**CITY OF YPSILANTI**  
**HISTORIC DISTRICT COMMISSION**  
**MINUTES OF July 12, 2016**

## **309 N Adams St**

**City of Ypsilanti**  
**Historic District Commission**  
**Work Permit Application**

EXISTING NORTH ELEVATION  
309 NORTH ADAMS STREET

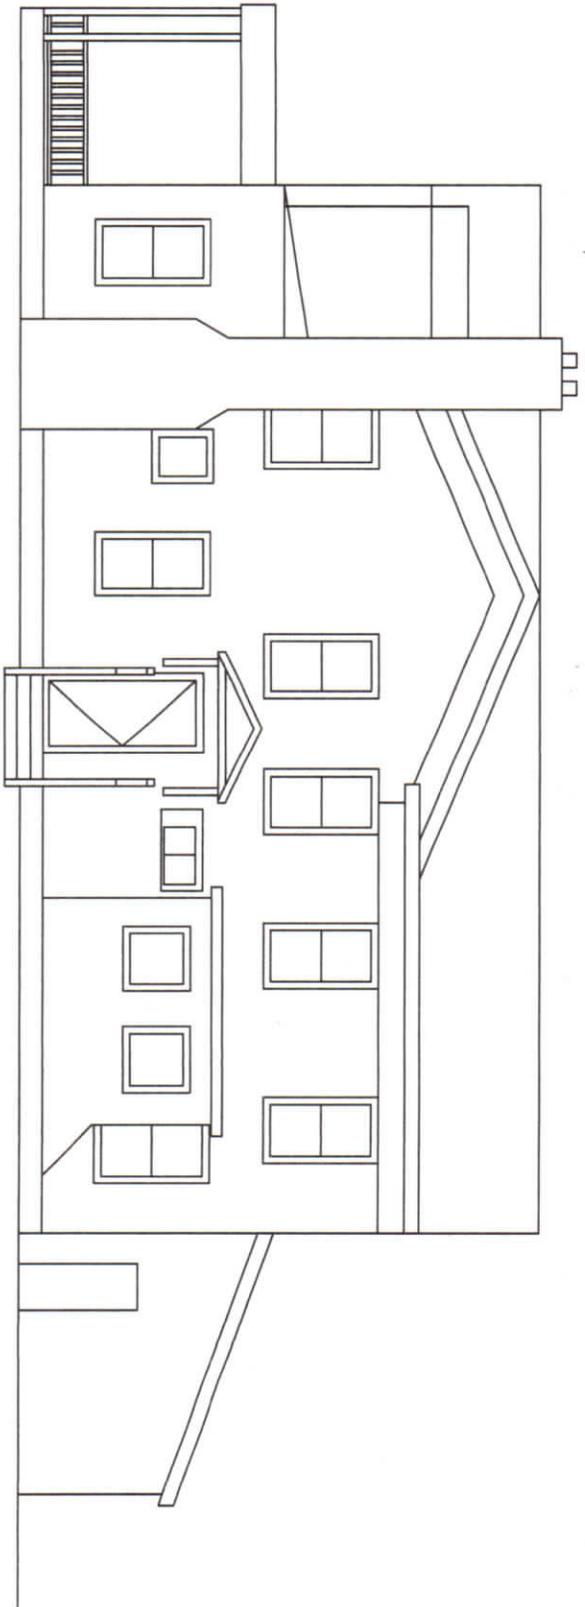
Stevenson: States that item three is the replacement of two small windows with a single, double-hung, operable window for egress. States that they saw this as a study item as well.

POORCH/SPIR  
RAIL PLAN  
(TYPICAL FOR  
BOTH ELEVATIONS)

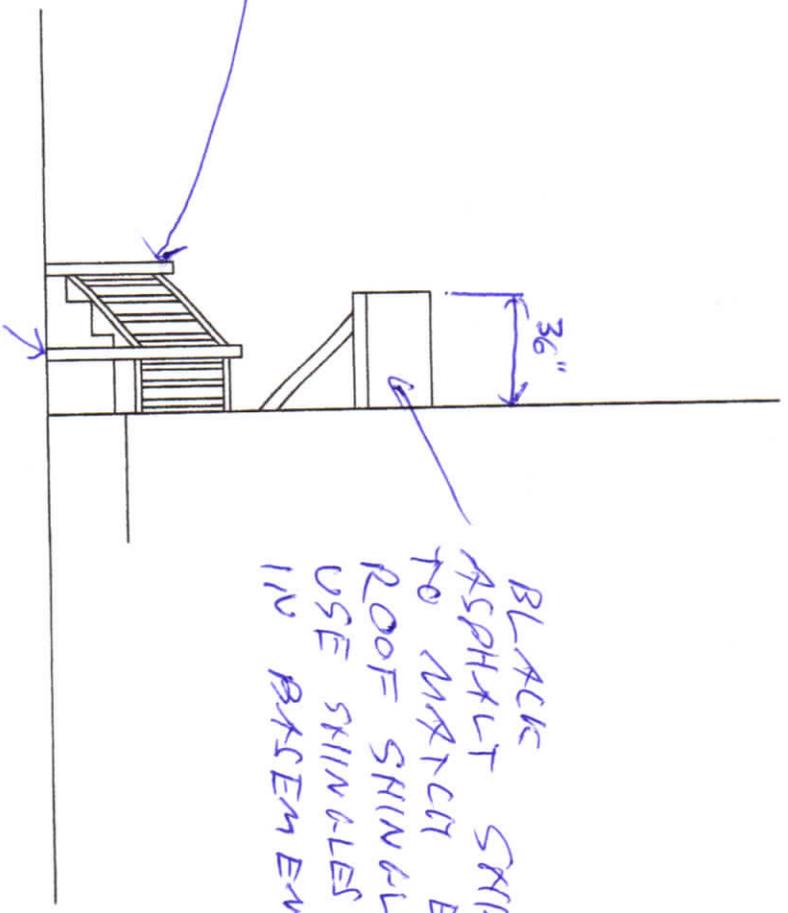
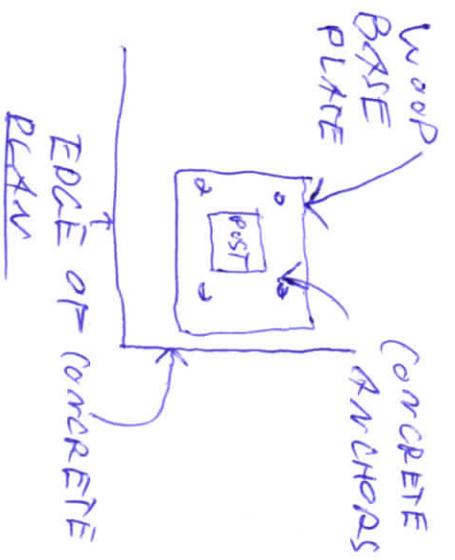
Pettit: States that there is a note about the attachment of the posts. States that in the drawings they are bolted to the sides, but he has provided an option to have a base plate anchored to the concrete. Asks the Commission for their opinion on which option to choose. States that looks-wise, the anchors in the plate look better. States that functionally, having it bolted to the side probably works better with the structural.

Pettit: States that he is OK with it on the side, states that it is hidden anyway and it will last longer.

ATTACH POST TO  
SIDE OF STOOD ANCHORS.  
WITH CONCRETE ALLOWED  
IF THAT IS NOT ALLOWED  
ATTACH POSTS TO TOP SURFACE  
OF PORCH WITH BASE PLATES

IF ATTACHING  
POSTS TO SOME OF  
CONCRETE STAIRS  
IS NOT ACCEPTABLE  
ATTACH WITH  
BASE PLATE

Porch roofs added to  
North and South elevations  
similar to these.

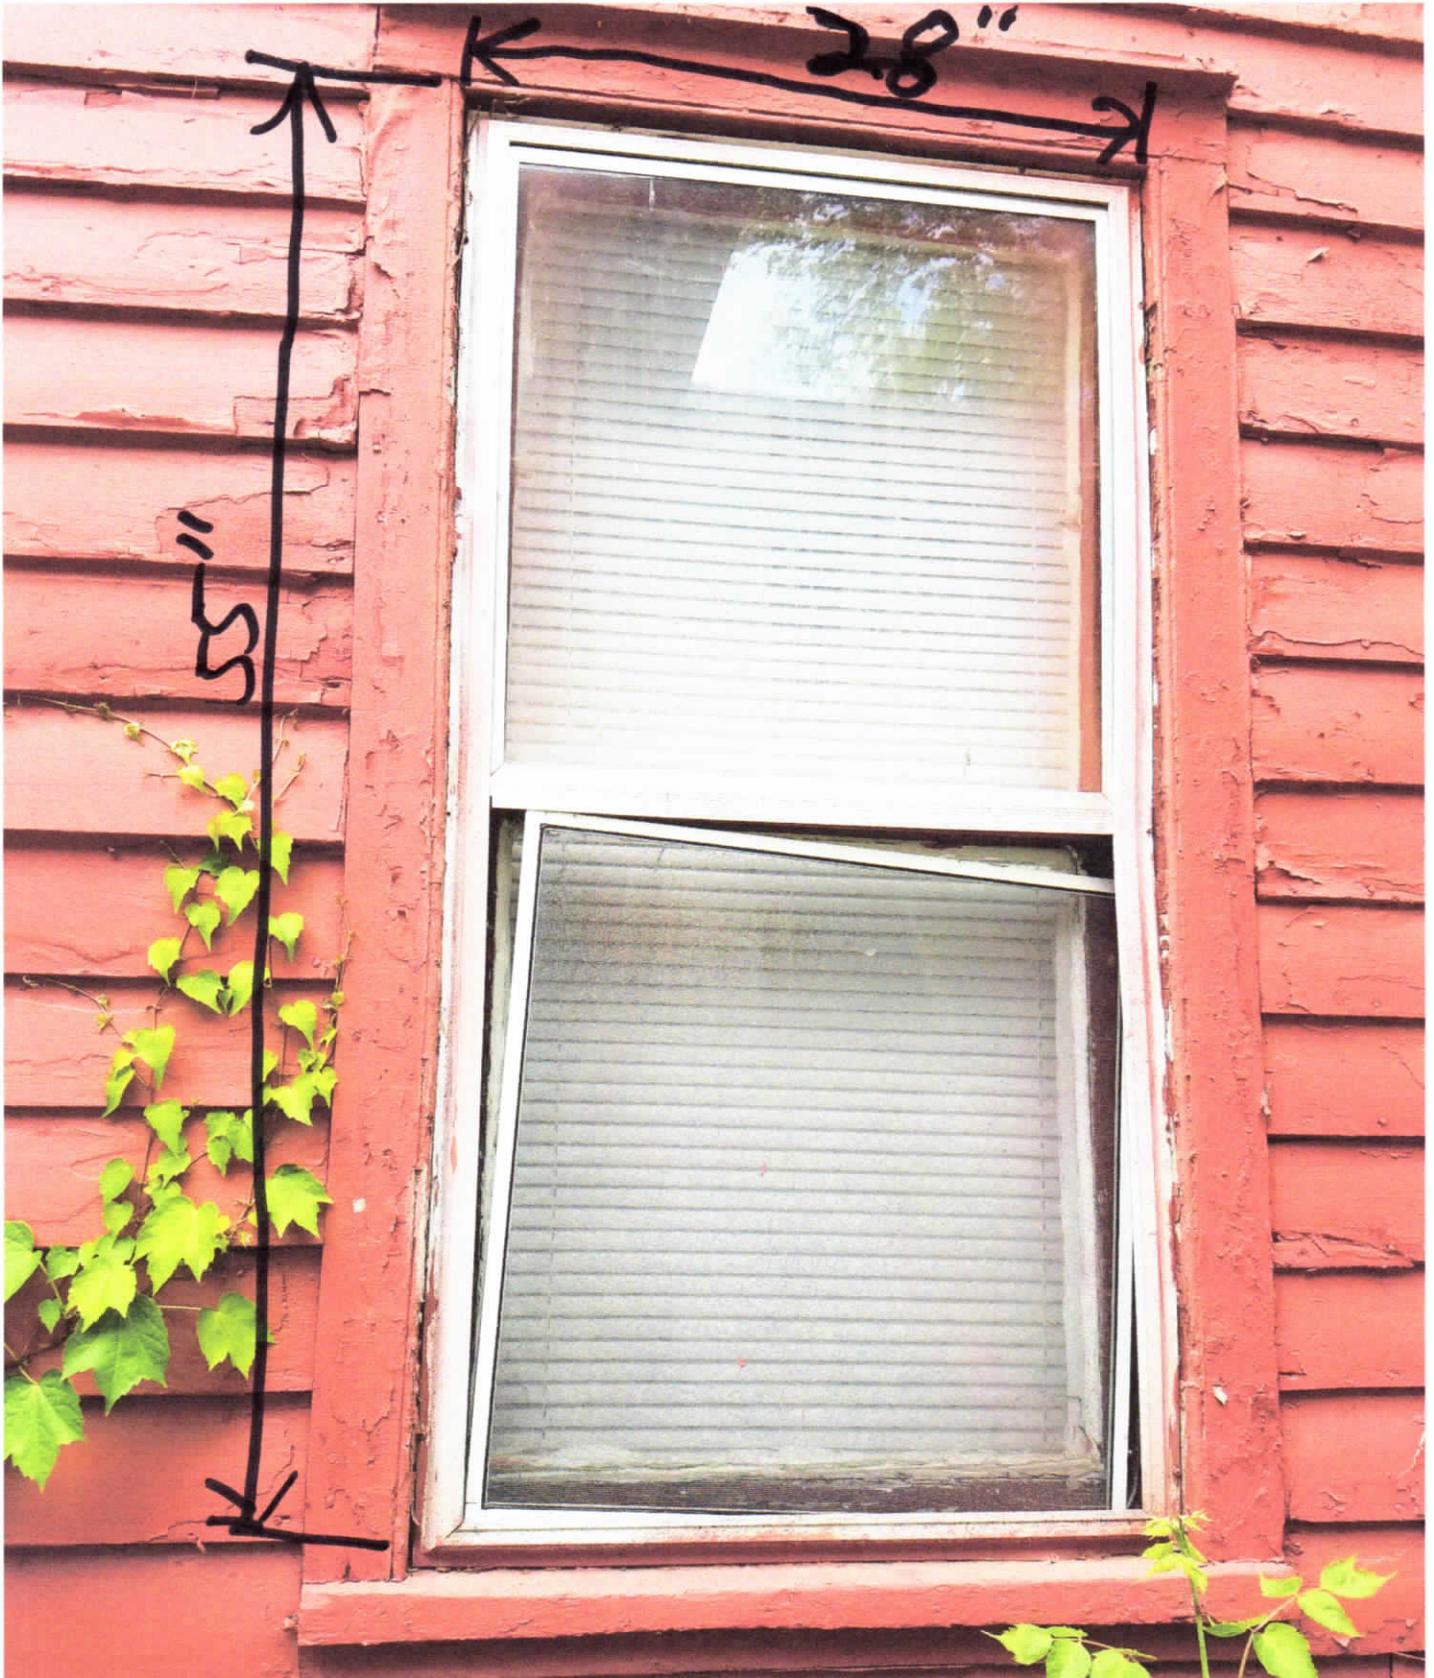
Stevenson: States that they discussed the security cameras and the reversal of the swing on the storm door. States that both items were fine. States that the next item is for adding roofs over the porches.

Pettit: States that he included some designs that they had talked about it. States that also with the exterior lighting is the porch light. States that it looks appropriate.
